Barnsley Metropolitan Borough Council
Head of Planning

Our ref : 153625-001

Planning Application reference 2025/0161 – Proposed mixed use scheme consisting of: Conversion of Grade II listed Coal Drops into Class E retail; new build extension to Coal Drops with Class E restaurant unit; Conversion of existing Regency House into Air BnB unit; and new build office and light industrial units (Class E) at Penistone Coal Drops, Regency House, Land at St Mary's Street, Penistone, Sheffield, S36 6DT

Sanderson Associates Consulting Engineers are appointed to advise the applicant for the above development on traffic and transportation matters and as such this letter has been prepared in response to the Highway Development Management consultation response dated 15 May 2025. A copy of this consultation response is attached at **Appendix A**.

Scale	1:200	Drawn By	AA
Drawing Size	A2	Checked By	KS
Date	February 2025	Approved By	KS
Drawing Number	153625-003	Rev	A

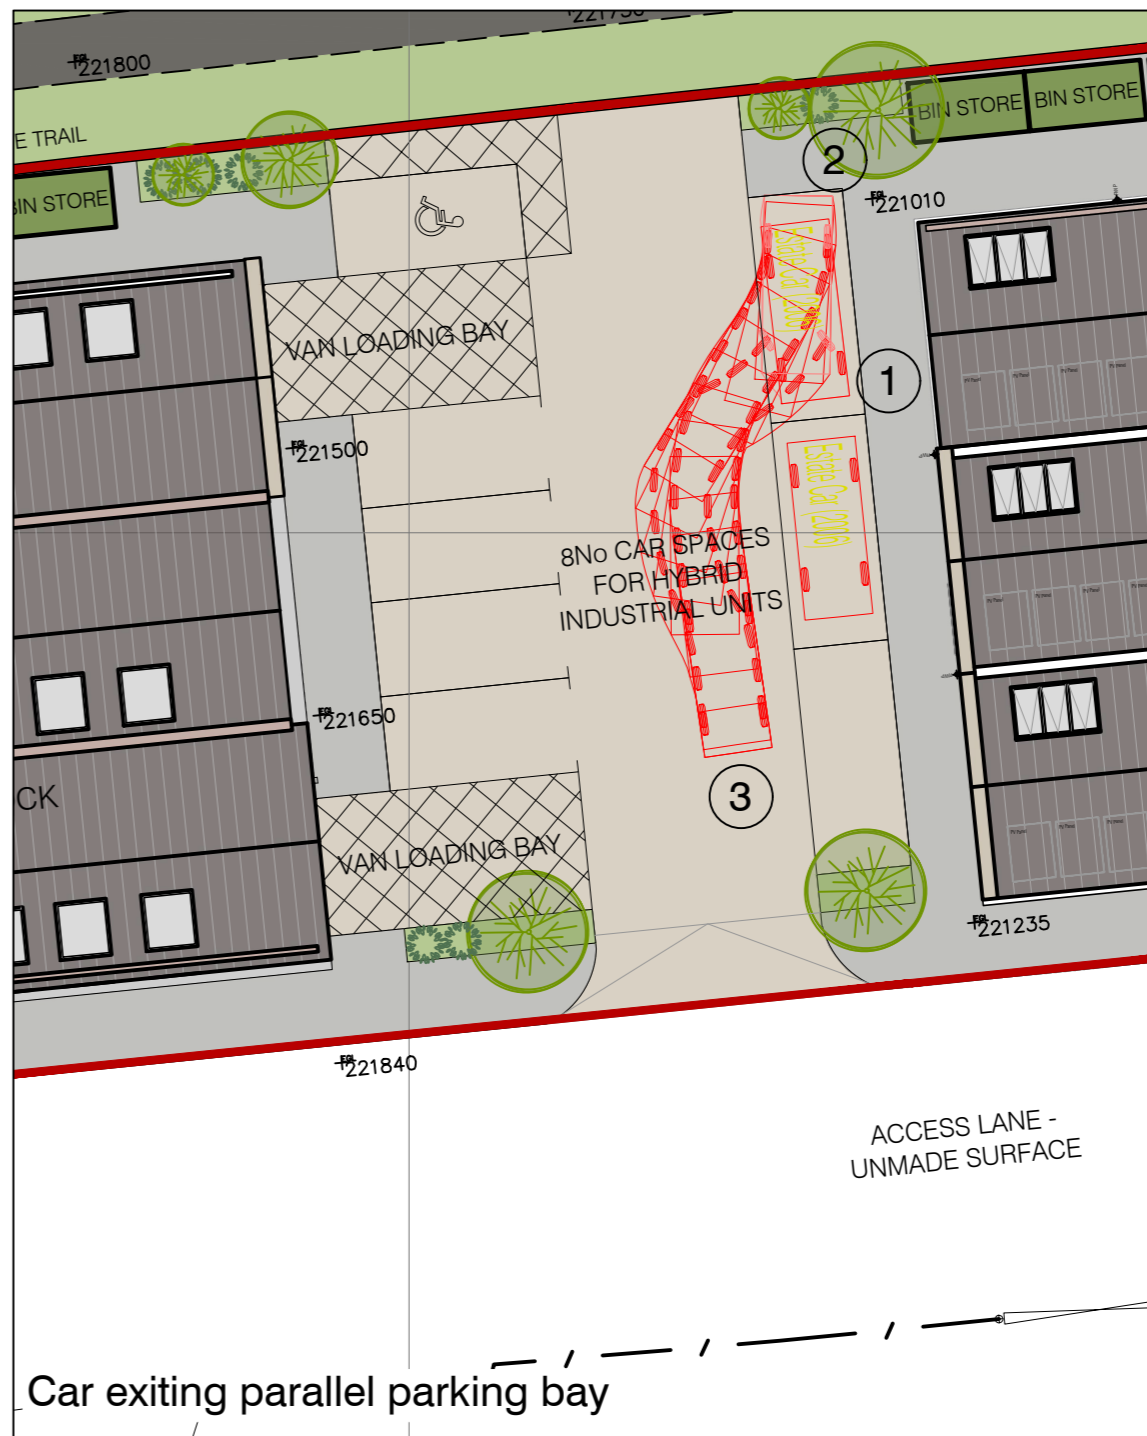
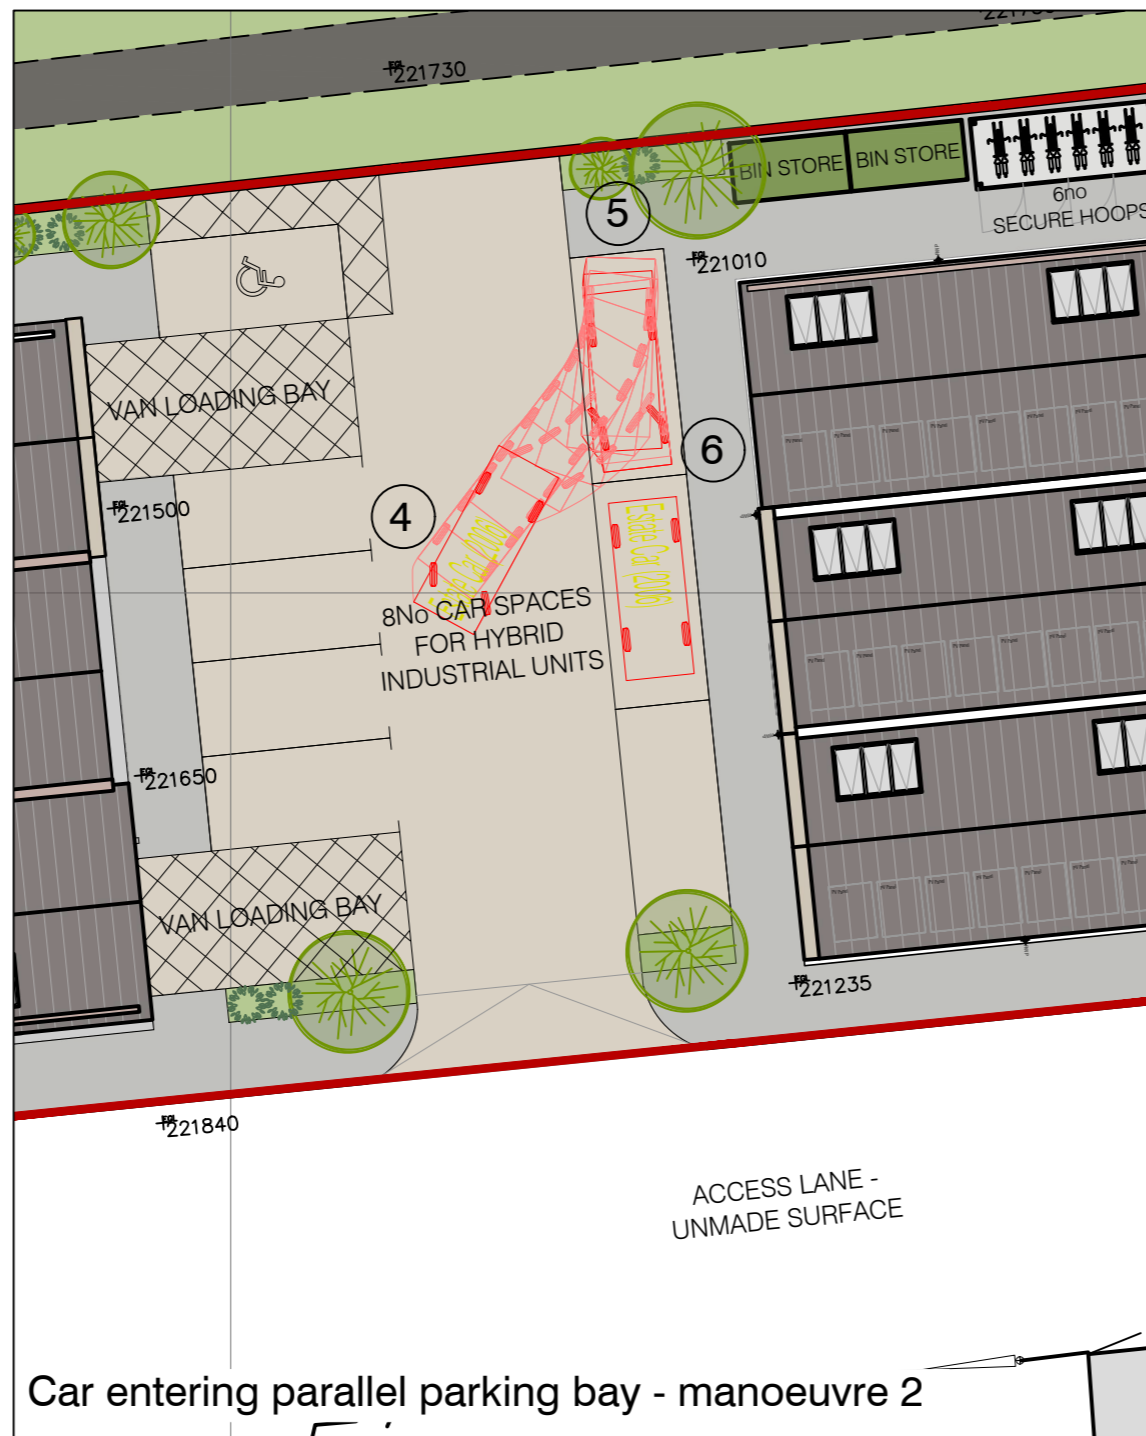
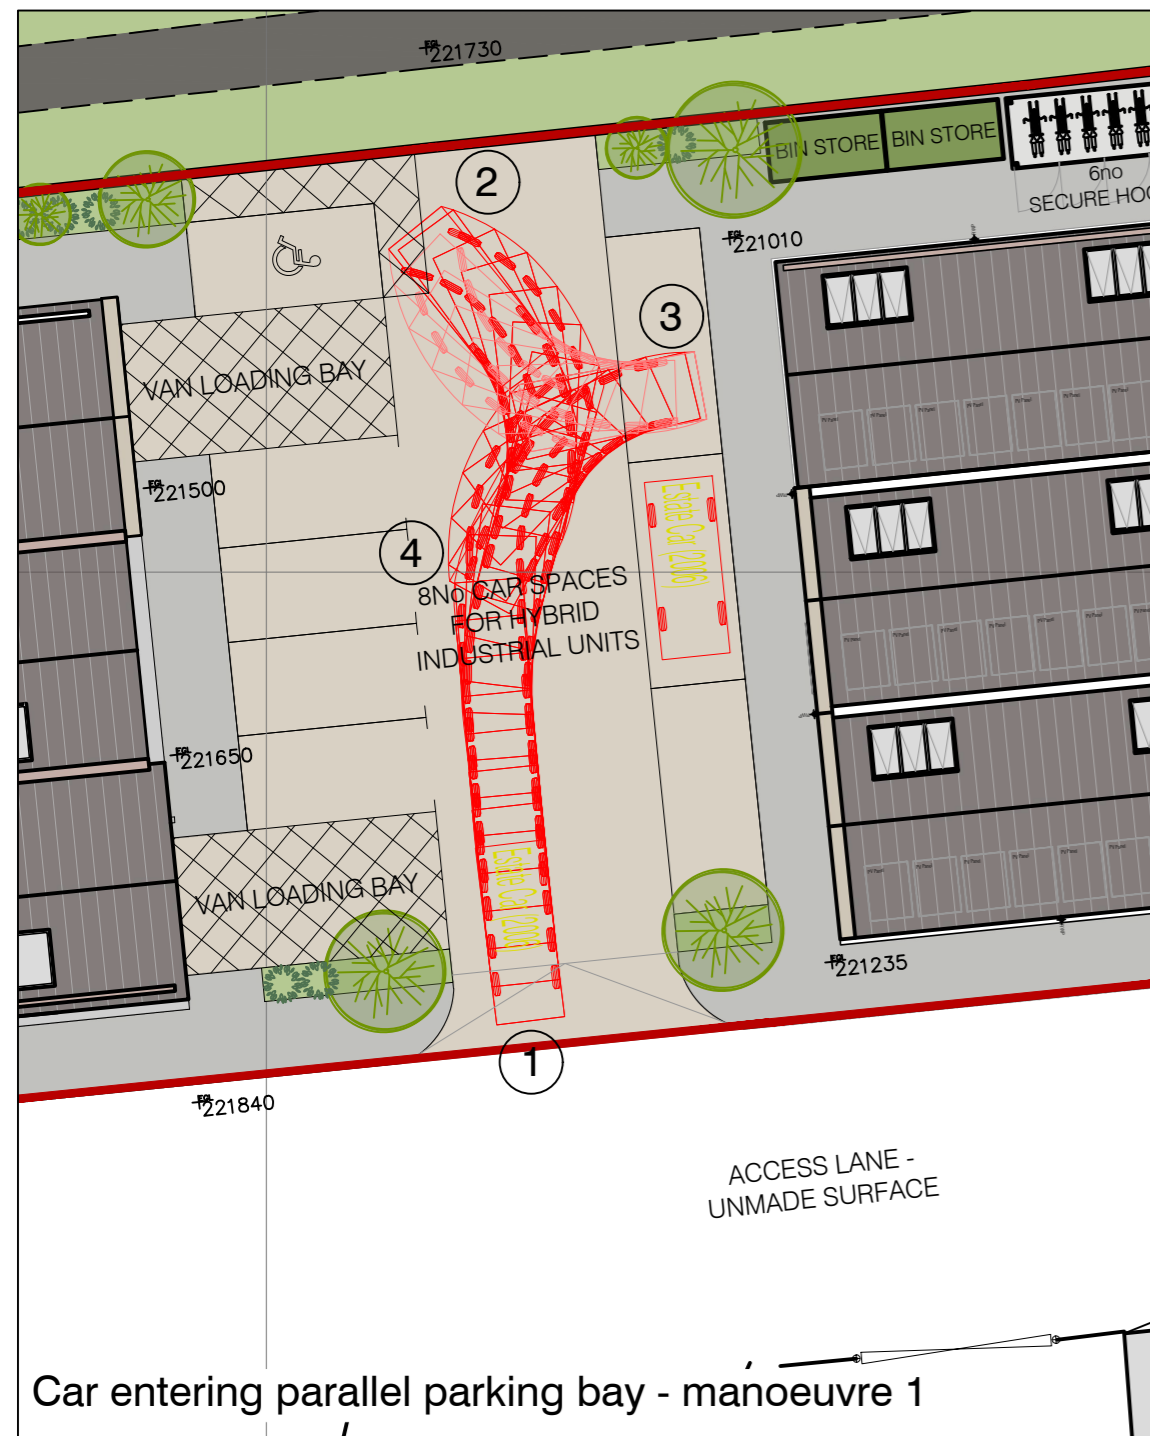
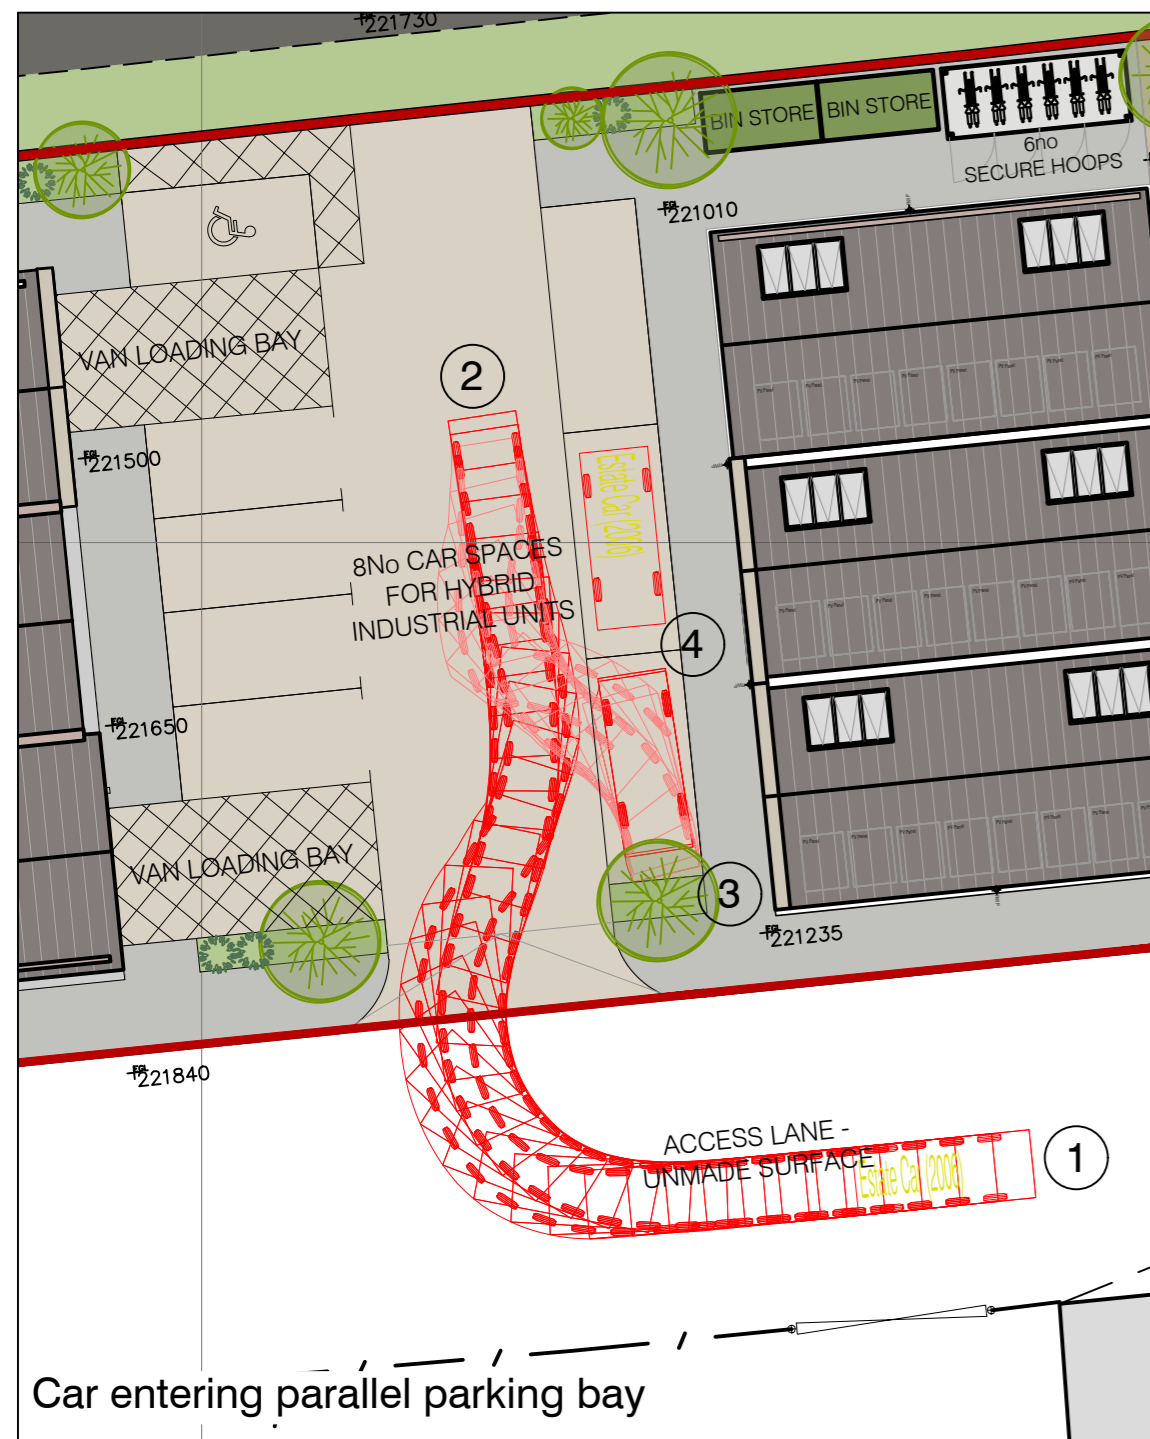
In addition, the layout of the parking areas raises further issues. When scaled, individual spaces appear to fall slightly below the minimum 5.0m x 2.5m dimensions, and several bays may prove difficult to access and manoeuvre within. In particular, the longitudinal bays along the site frontage are likely to require reversing out of the site or complex turning movements within the site, both of which are undesirable.

The Highway Officers comments reference “*longitudinal bays along the site frontage*” and we have assumed that this refers to the three parallel bays within the central part of the site. In order to clarify the vehicle manoeuvres which would be required to access and egress these bays please see Drawing 153628-003 Rev A, attached at **Appendix C**.

This demonstrates that all three bays can be utilised without undue manoeuvring and without any impact outside of the site boundary. For clarity the entry manoeuvre to the innermost parallel bay is shown over the lower left and lower central viewport as combining the various vehicle tracks would make the individual movements indistinguishable.

Drawing 153625-003 also demonstrates the accessible bay in the central area being utilised.

Drawing 27845_A(01)02_P03 (proposed site plan)

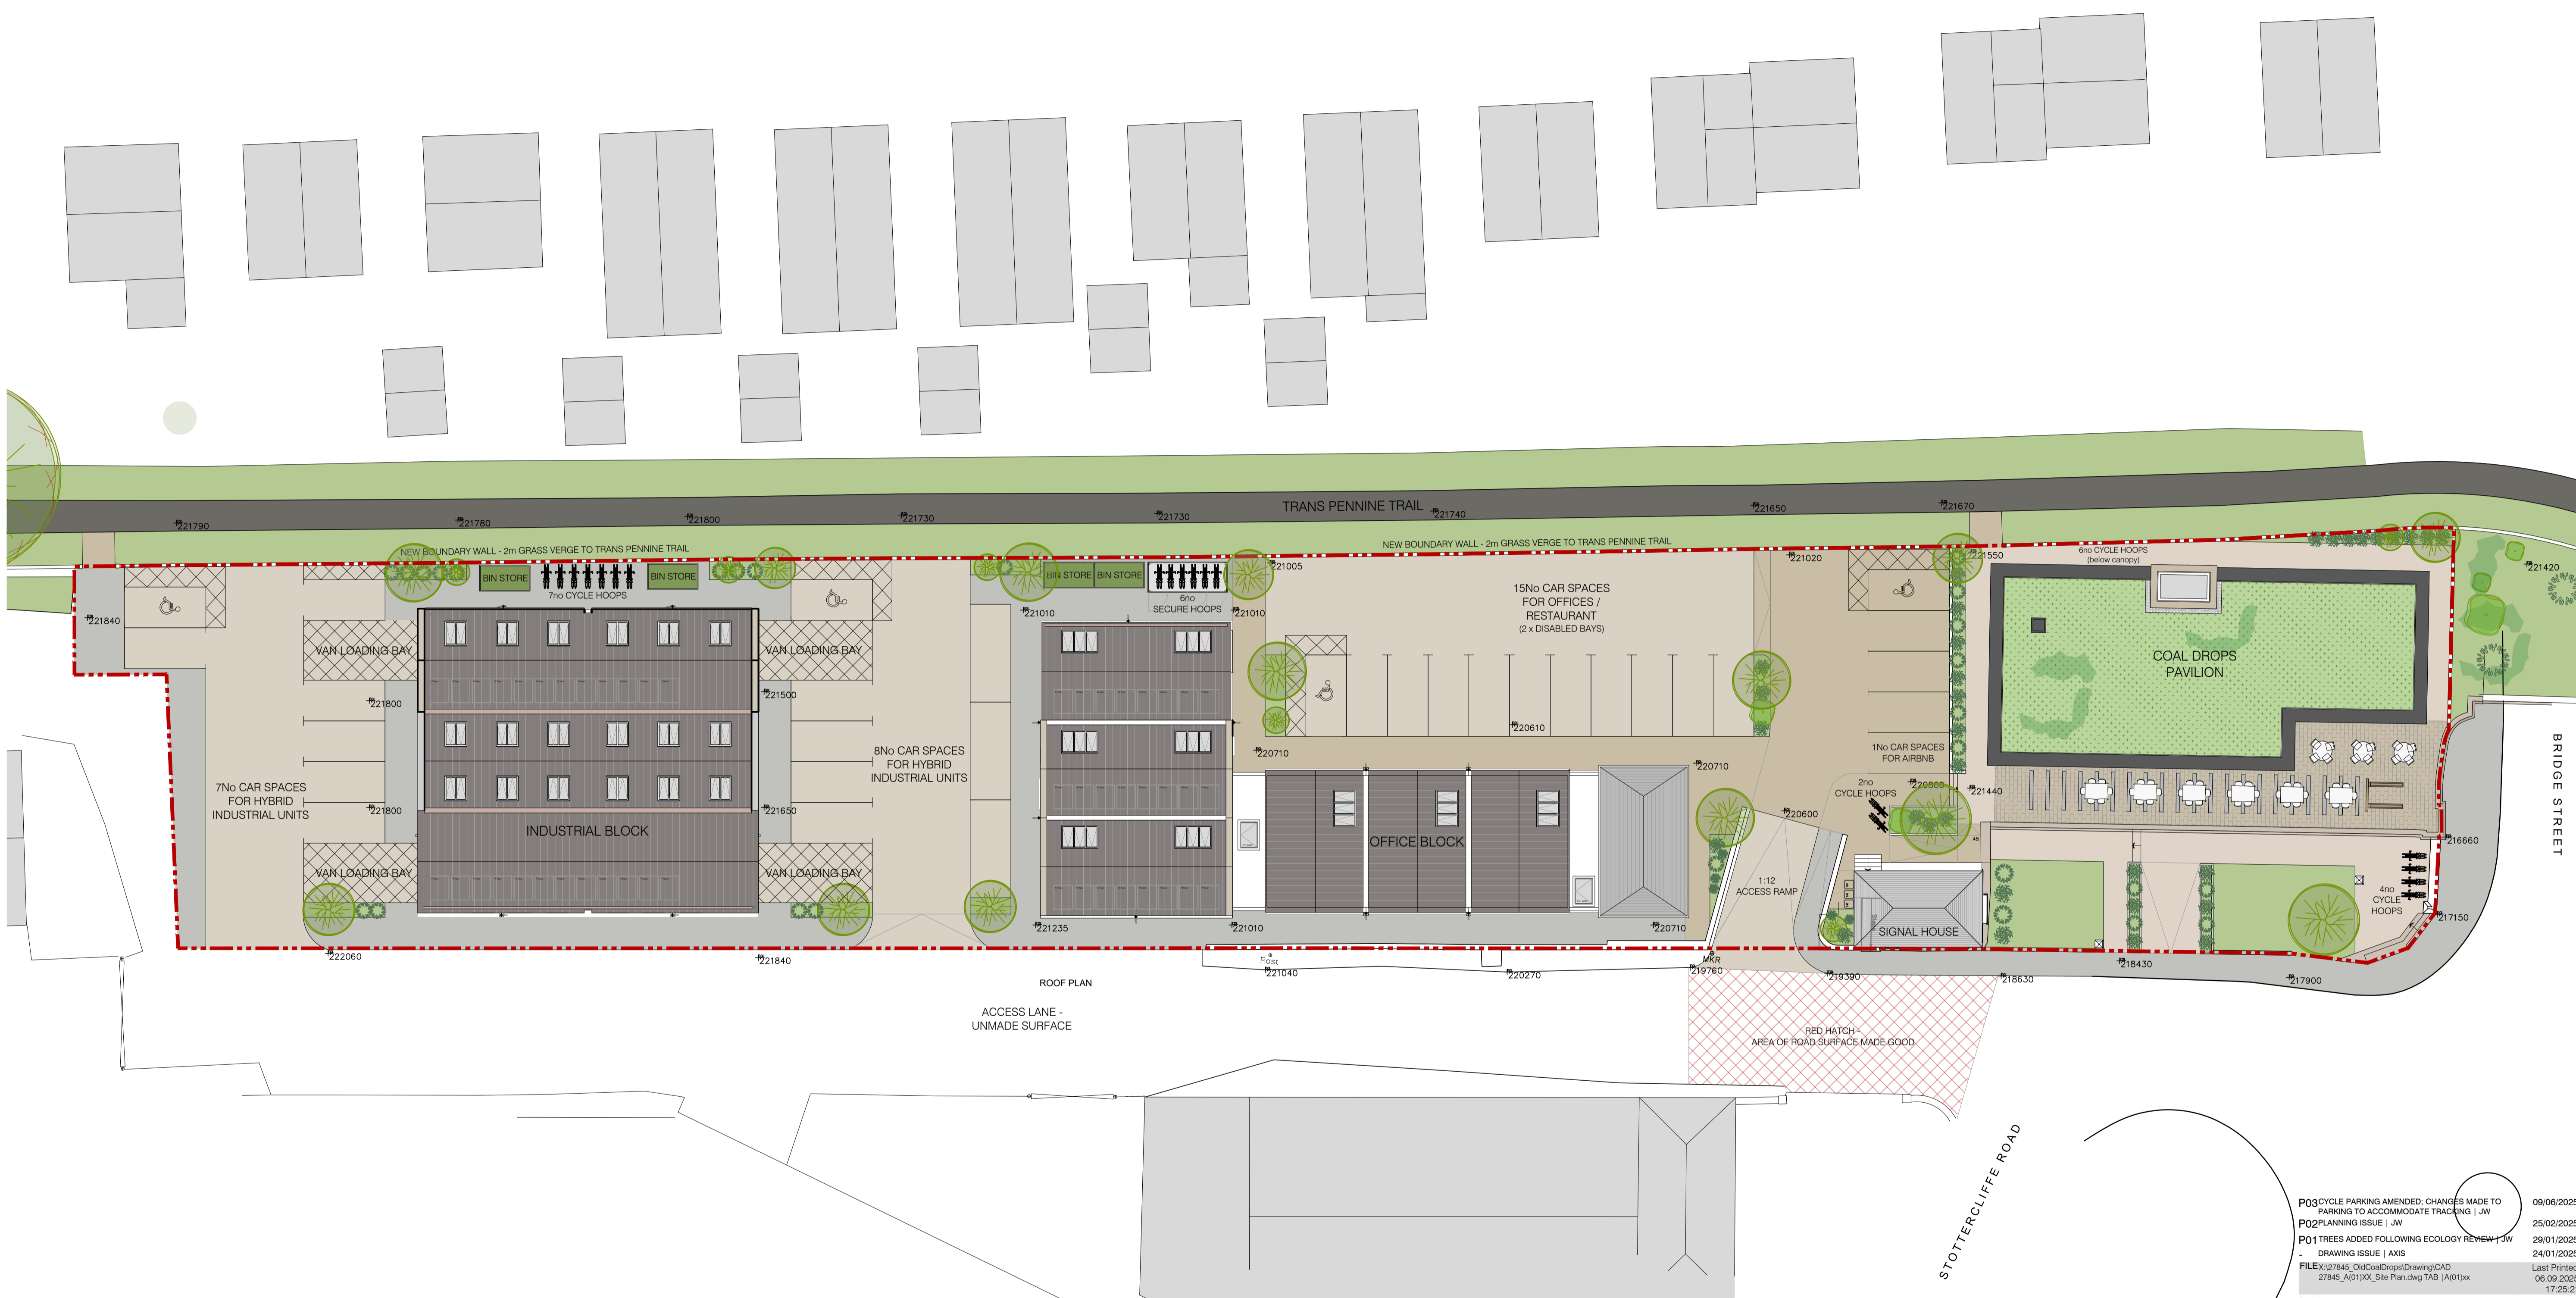
Cycle parking provision also appears inadequate, particularly given the site’s intention to attract users of the Trans Pennine Trail and the limited vehicle parking proposed. A greater quantity of secure, accessible cycle storage should be provided.

Through liaison with Axis Architecture, cycle parking provision has been increased across the site. This is demonstrated on Drawings 27845_A(01)02_P03 (proposed site plan) and Drawing 27845_A(02)04-P02 (Coal Drops - upper ground floor), attached at **Appendix E**, and includes the following:-
